SERVICE BULLETIN: JSB 042-1

Subject: Jabiru Aileron control tube

Affected Models: All aircraft

Figure 1 – Elevator cable layout example

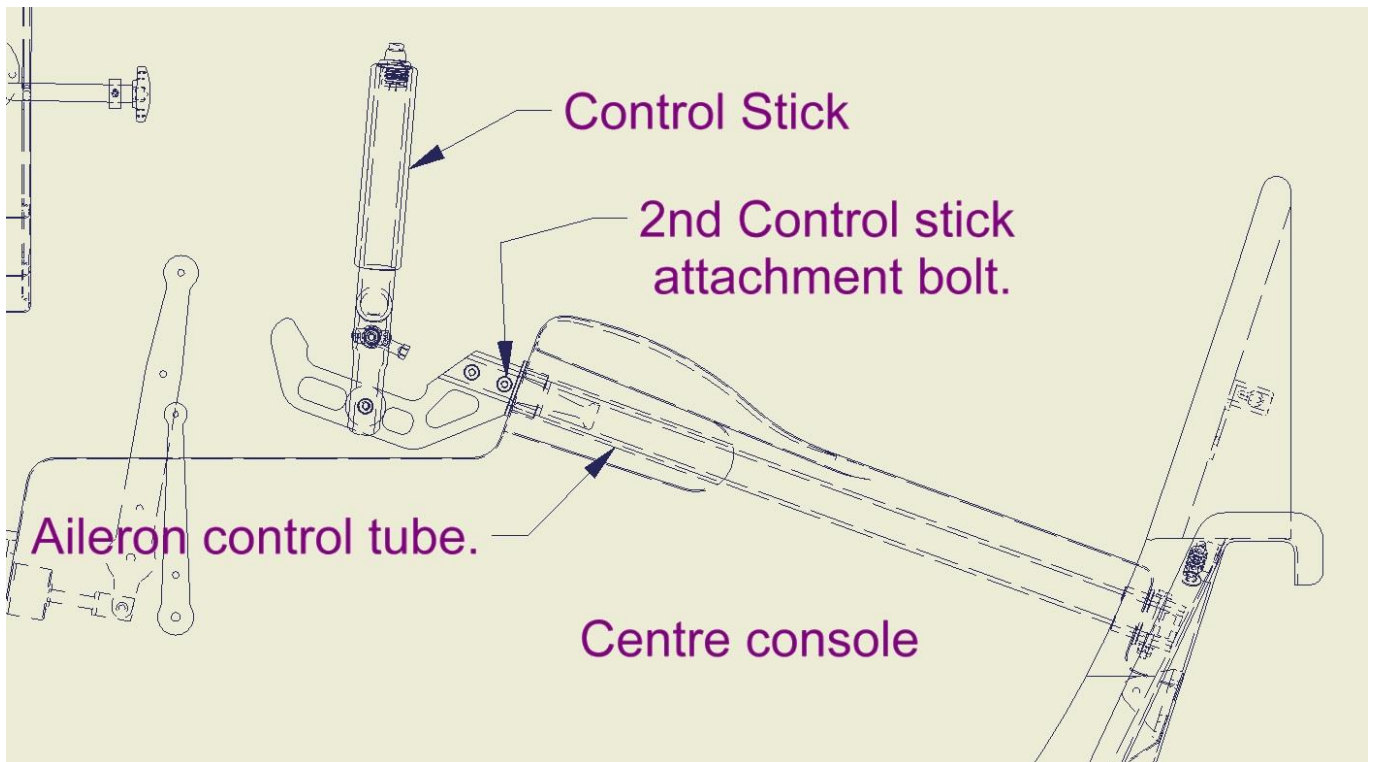
- The Jabiru Aileron Control Tube is a machined aluminium tube that runs from the control stick assembly through the centre console to the aileron cable bell-crank. Refer to Figure 1 for correct terminology.
